QUALITY ASSURANCE -- NON-CONFORMANCE REPORT

Report No: NCR-000695

Reference Description: Excessive heat was utilized during heat straightening of the traveler rail 11TR2-007

Dear: Mr. Charles Kanapicki
Job Name: SAS Superstructure

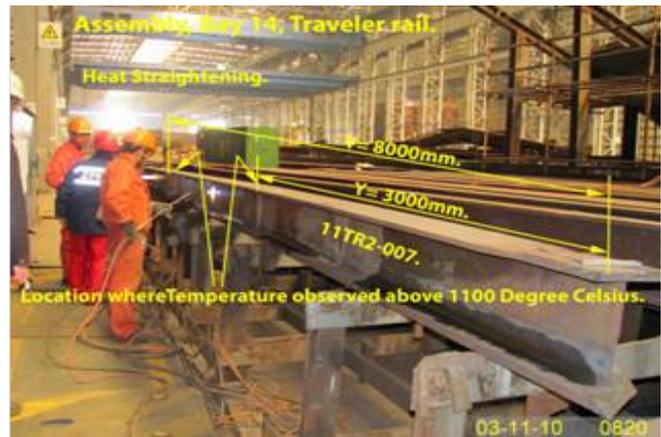
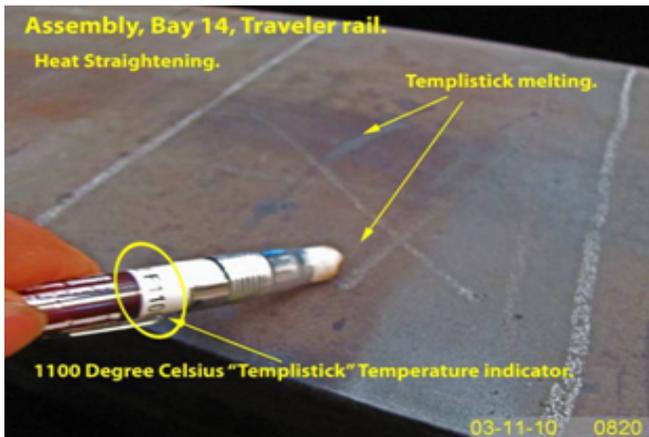
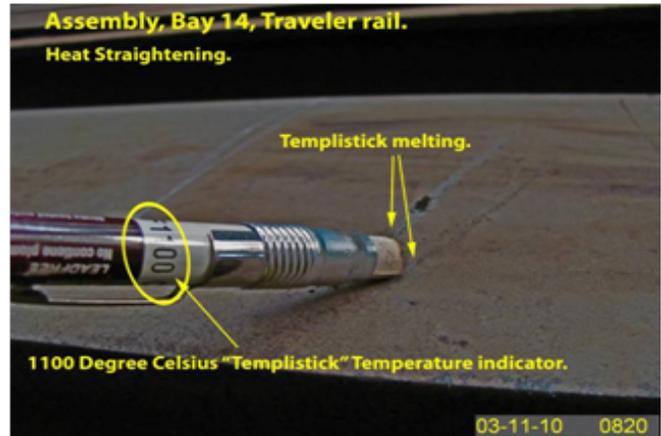
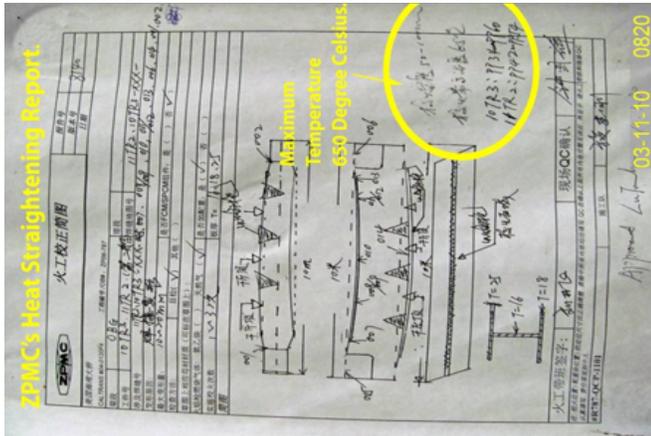
During the Quality Assurance (QA) random in-process visual inspection of OBG traveler rail Heat Straightening, this QA Inspector observed the following:

- Temperature of the heat straightened traveler rail was beyond the allowable 650 Degree Celsius in two locations.
- Per ZPMC heat straightening report (HSR) maximum temperature limit is 650 Degree Celsius.
- The 1100 Degree Celsius rating "templistick" was melted when check was made against the metal surface.
- "Y" location of the spots identified as 3000mm & 8000mm at the flange.
- The Traveler Rail is identified as 11TR2-007.

Hardness testing 11TR2-007

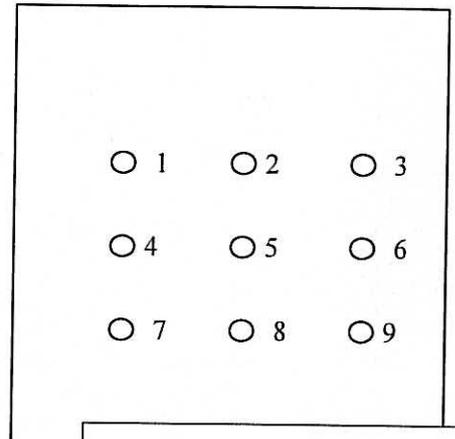
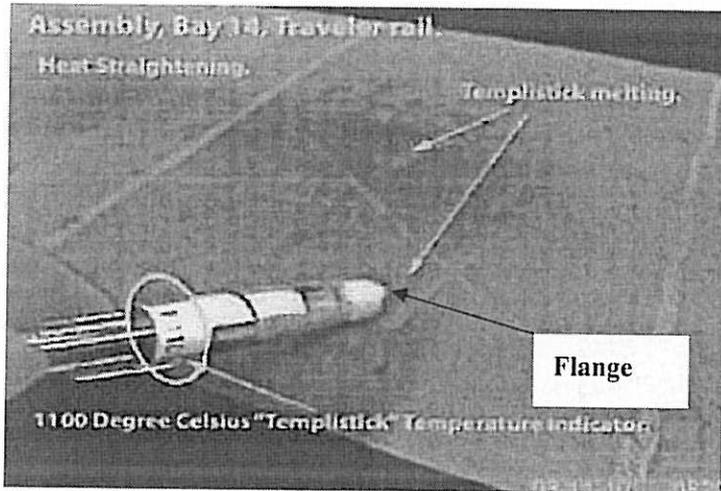
Tested points were located by 50mm * 50mm Square on the HS surface & compare area

Flange			
HS Area (3000~3150mm)		No HS Area (1950~2100mm)	
Location	Data	Location	Data
1	148	1	165
2	156	2	171
3	164	3	161
4	134	4	134
5	142	5	140
6	166	6	152
7	151	7	193
8	149	8	158
9	151	9	157

Remark: The compare area what called No HS Areas were located away from the HS Areas at same plate.

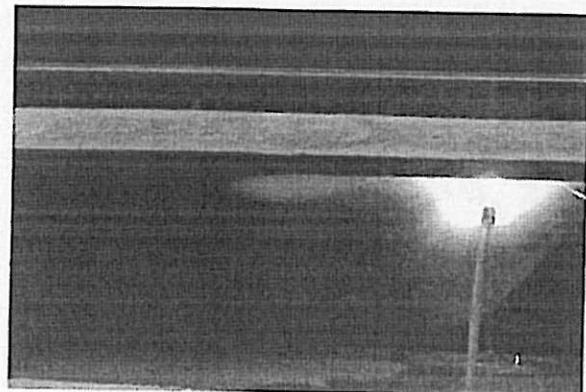
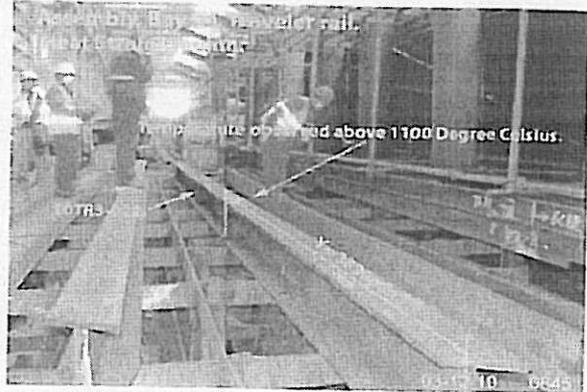
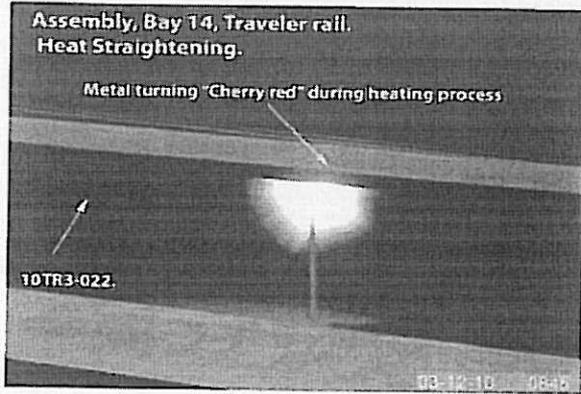
During the Quality Assurance (QA) random in-process visual inspection of OBG traveler rail Heat Straightening, this QA Inspector observed the following:

- Temperature of the heat straightened traveler rail was beyond the allowable 650 Degree Celsius.
- Metal color turns into "cherry red" after it was heat straightened.
- Per ZPMC heat straightening report (HSR) maximum temperature limit is 650 Degree Celsius.
- The 1100 Degree Celsius rating "templistick" was melted when check was made against the metal surface.
- "Y" location of the spot identified was 3890 mm and it is at the flange to web joint.
- The Traveler Rail is identified as 10TR3-022.

Hardness testing 10TR3-002

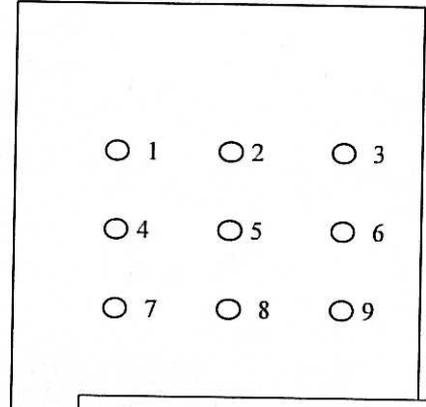
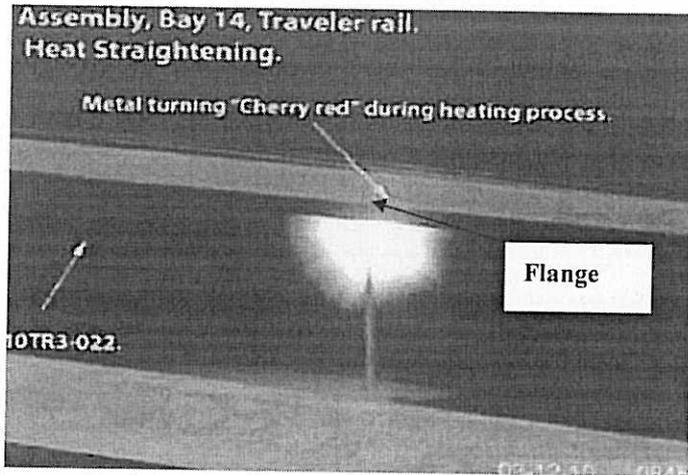
Tested points were located by 50mm * 50mm Square on the HS surface & compare area

Flange			
HS Area (3800~4000mm)		No HS Area (3000~3200mm)	
Location	Data	Location	Data
1	157	1	153
2	191	2	146
3	147	3	141
4	160	4	160
5	144	5	144
6	149	6	139
7	148	7	138
8	144	8	153
9	149	9	149

Remark: The compare area what called No HS Area was located away from the HS Areas at same plate.

11TR2-007 Flange at 3000mm Hardness Testing Result

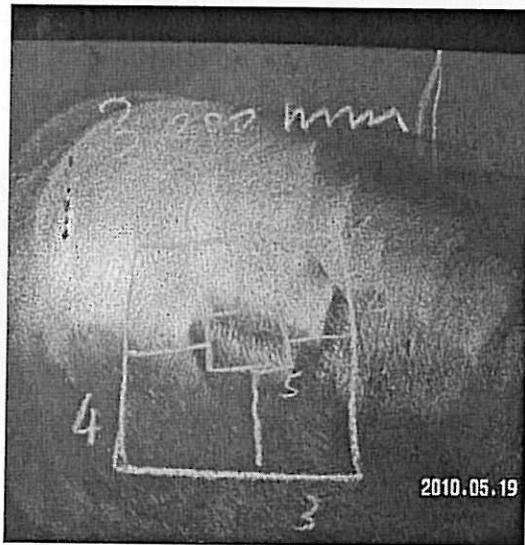
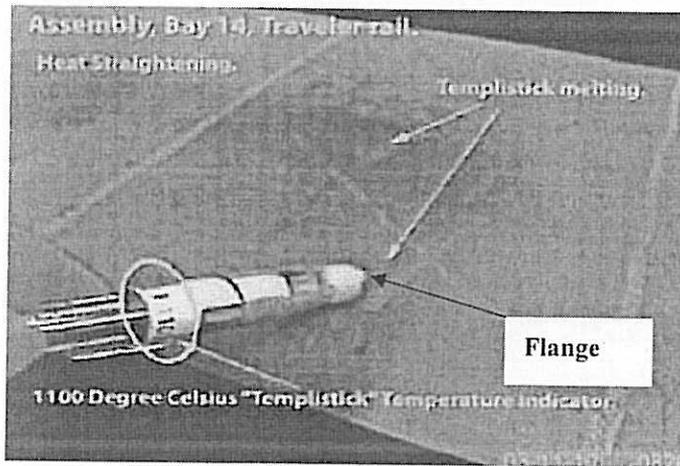
Area \ Value	a	b	c	d	e	Average Value
1	203	242	218	243	208	223
2	184	201	195	193	166	191
3	189	267	219	200	196	205
4	225	197	197	201	208	202
5	239	190	200	200	196	199

11TR2-007 Flange at 8000mm Hardness Testing Result

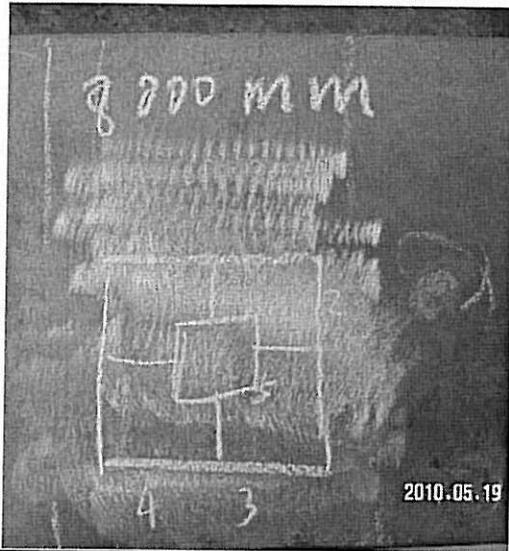
Area \ Value	a	b	c	d	e	Average Value
1	181	180	191	192	196	188
2	212	213	178	189	196	199
3	216	221	209	194	217	214
4	210	225	198	234	217	217
5	212	199	195	209	194	201

Remark: The highest and the lowest readings are discarded when calculating the average value.
